August 13, 2020
File No. 09215600.10

Subject: Southeast County Landfill (SCLF), Hillsborough County
Operation Permit Minor Modification Application
Responses to Request for Additional Information (RAI)
WACS No. 41193
DEP Application No. 35435-028-SO-MM

FIGURE 3-1. PHASES I-VI LEACHATE COLLECTION AND REMOVAL SYSTEM
HILLSBOROUGH COUNTY
JUNE 2020

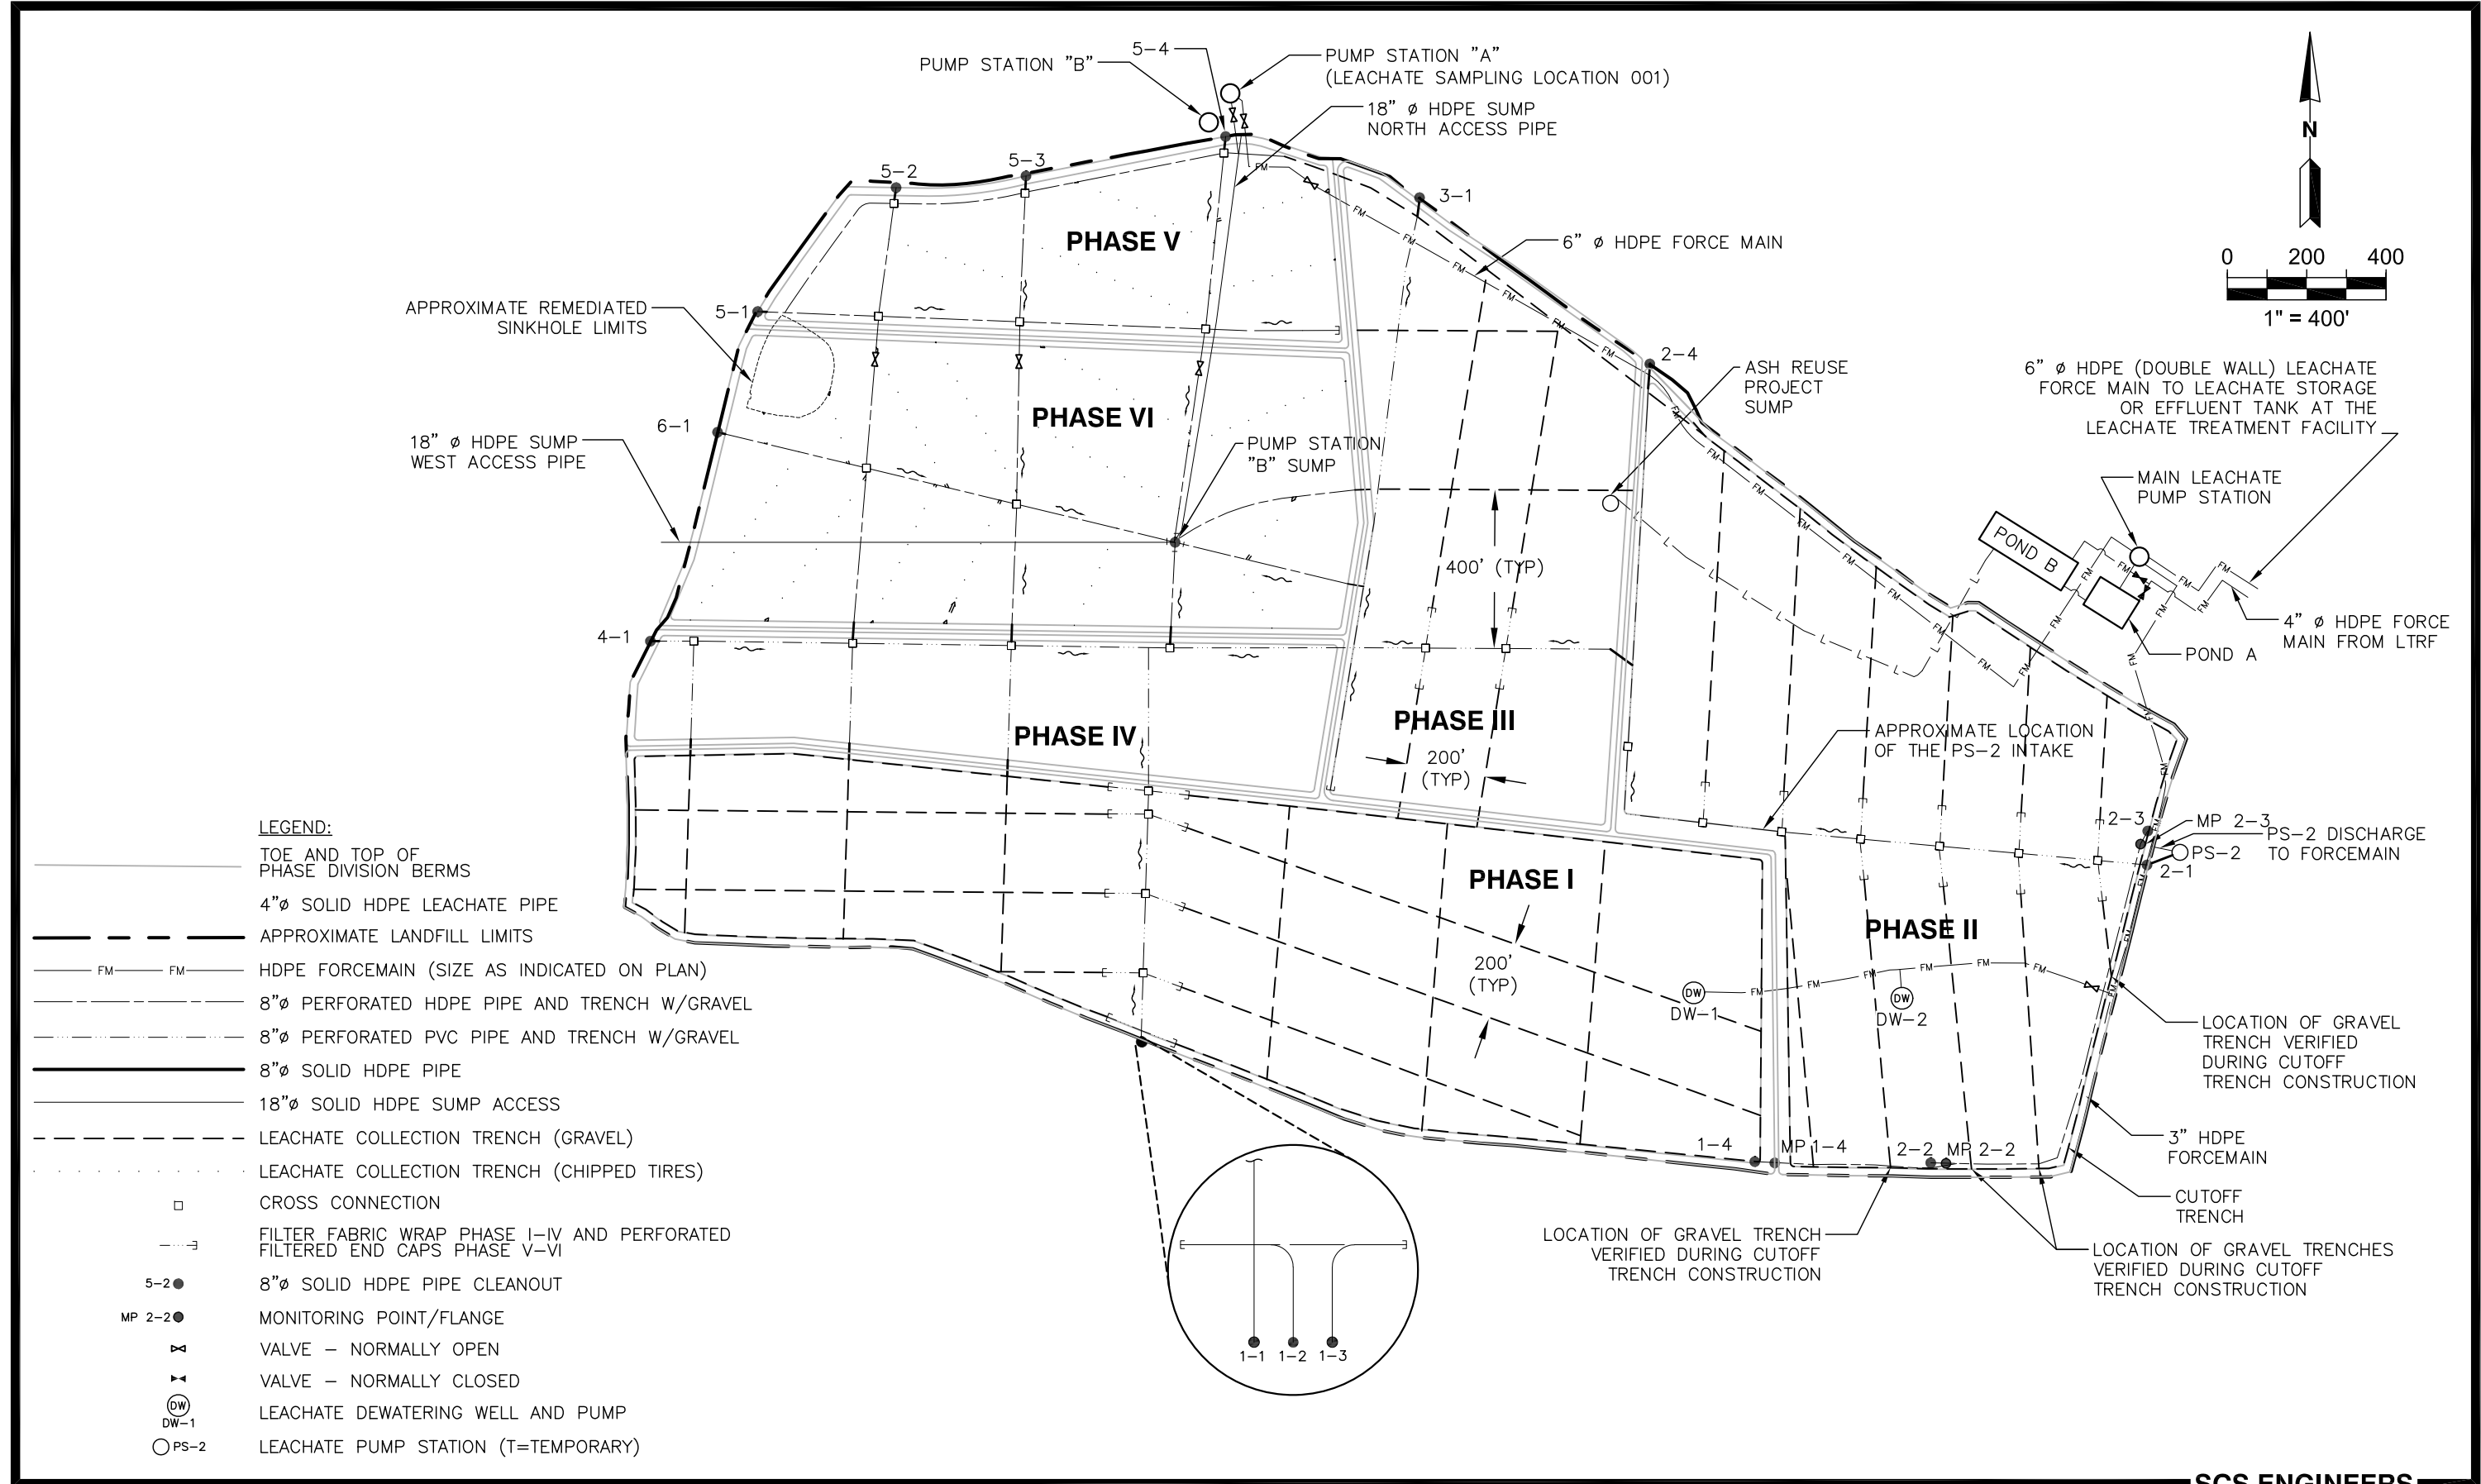
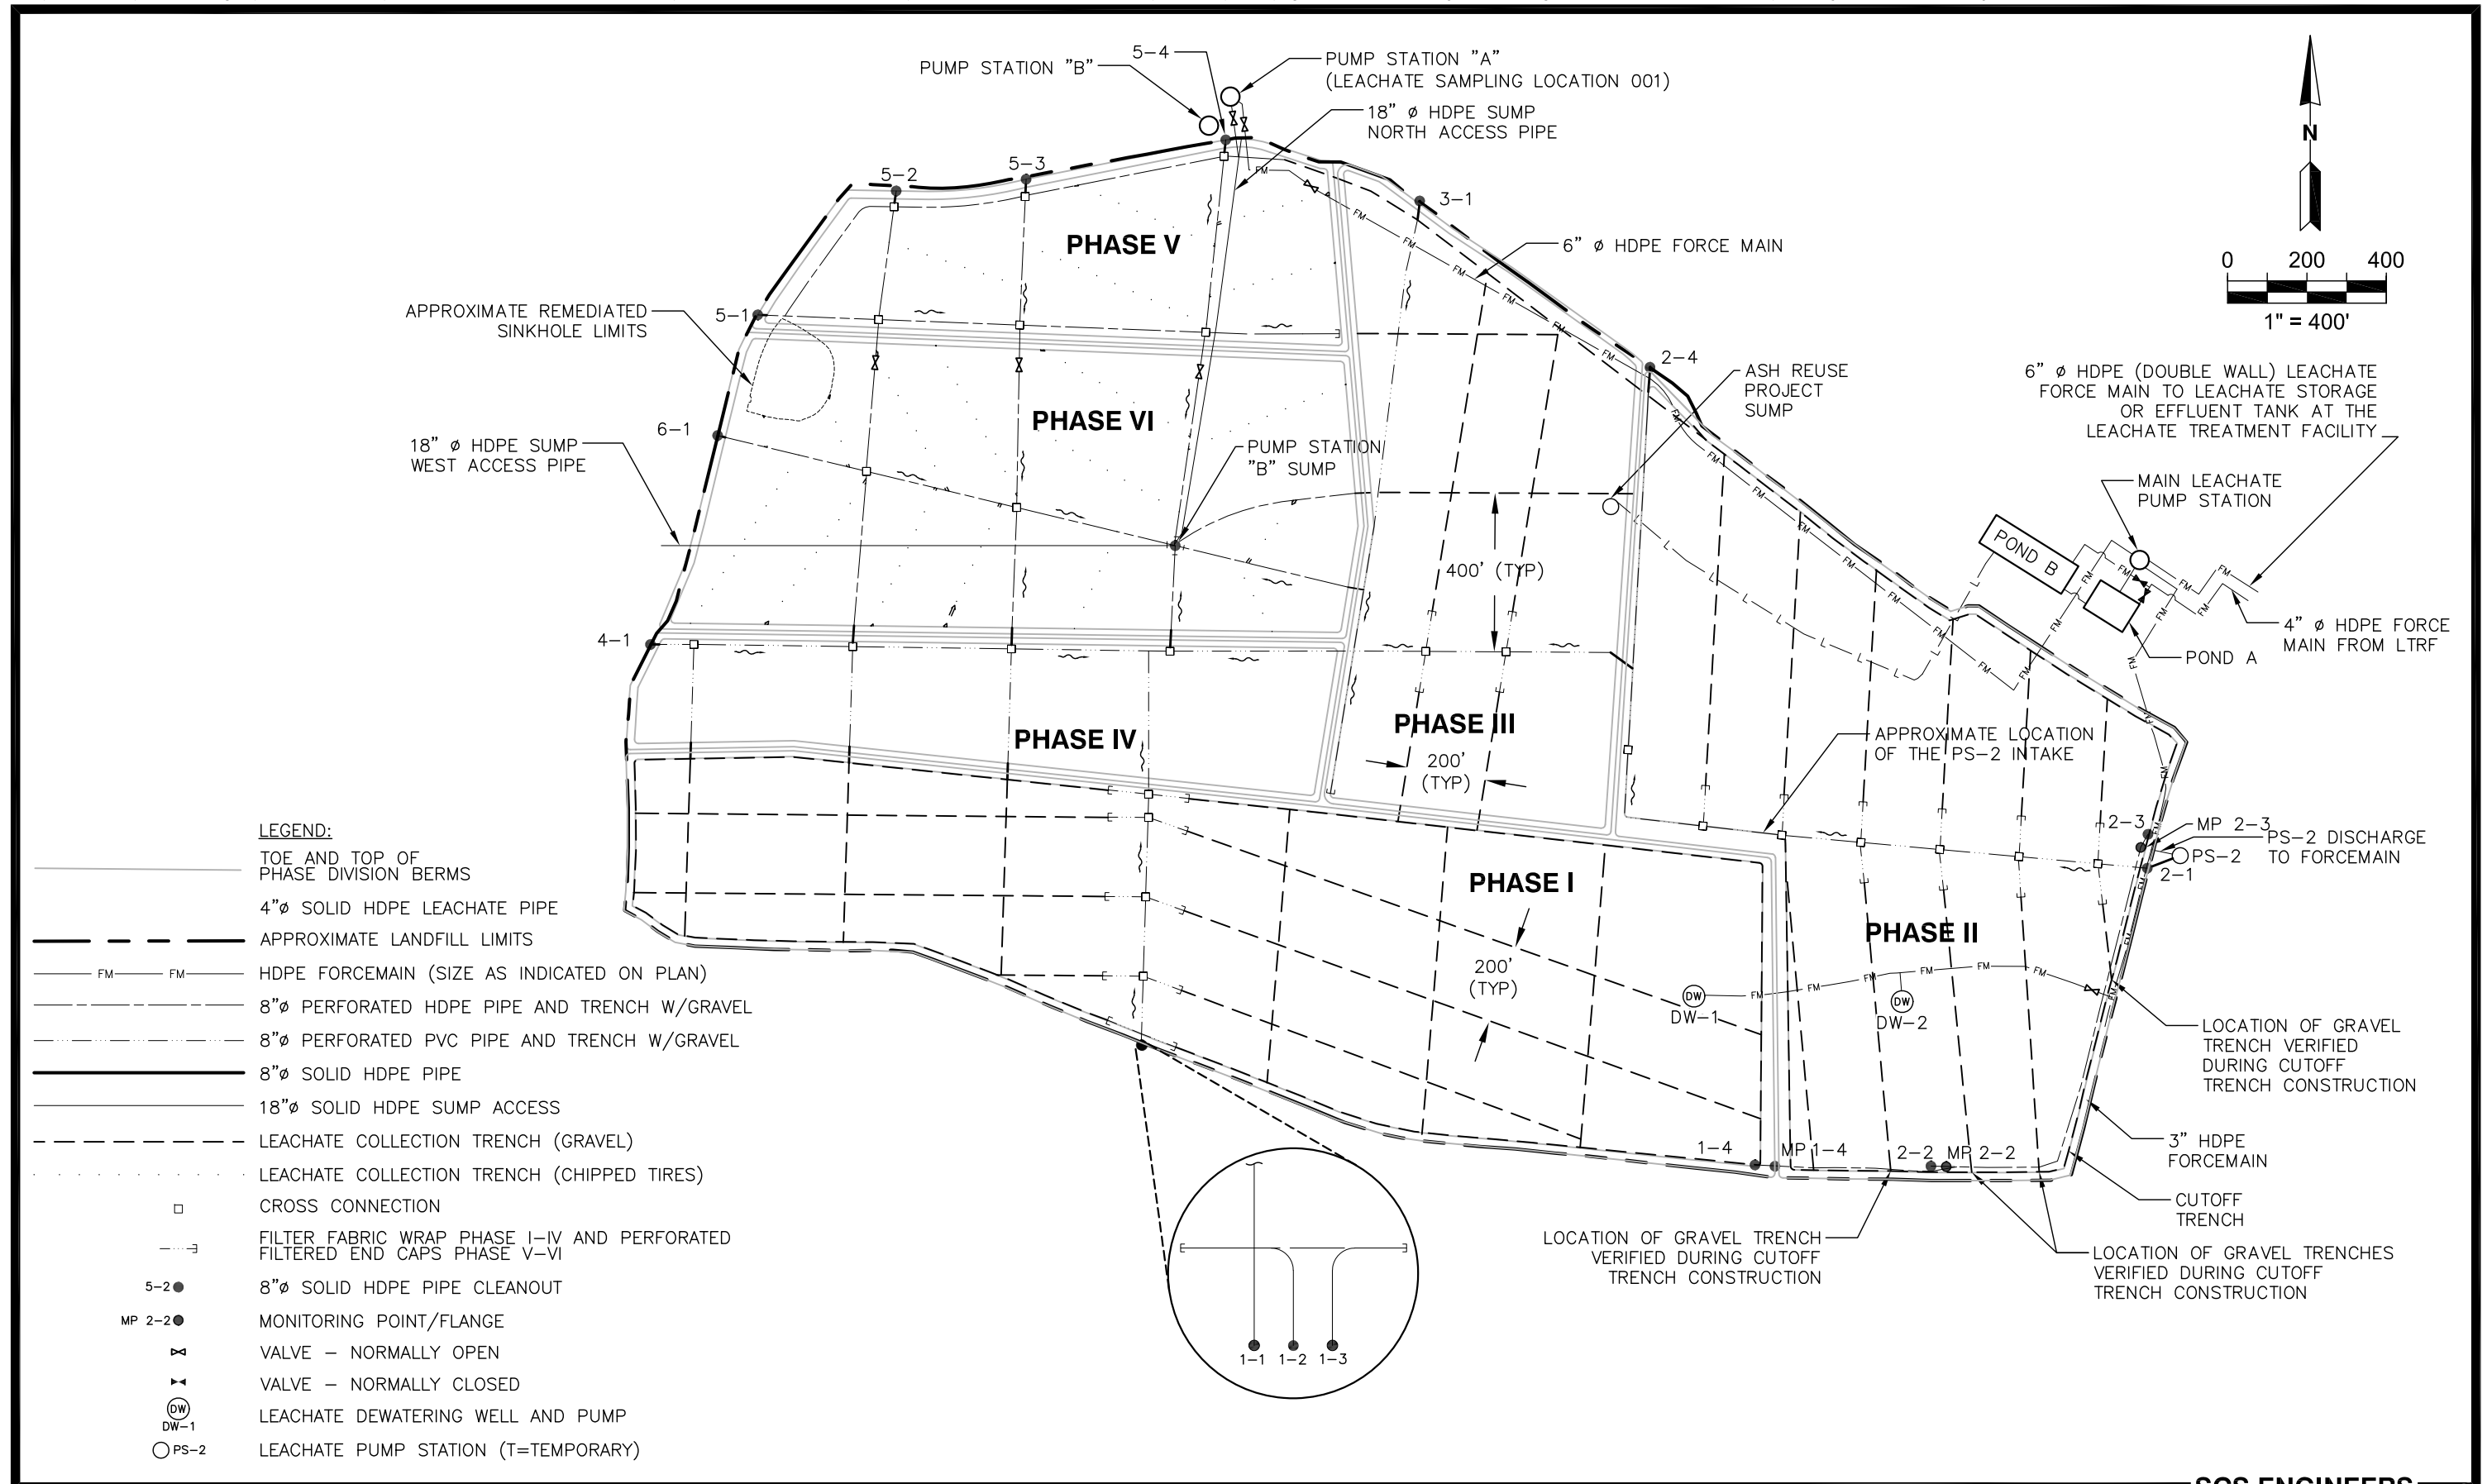
- **[PDF p. 86] Appendix A Revised Leachate Management Plan. Update Figure 3-1 by deleting the old compost sump line into Pond B. Regulation Reference: Paragraph 62-701.500(2)(j), F.A.C.**

Response: Figure 3-1 of the LMP has been updated to reflect the removal of the pilot composting area leachate line. A conformed LMP with changes identified in this letter is provided as **Attachment 1**. A LMP with changes identified in redline and strikeout is provided as **Attachment 2**.
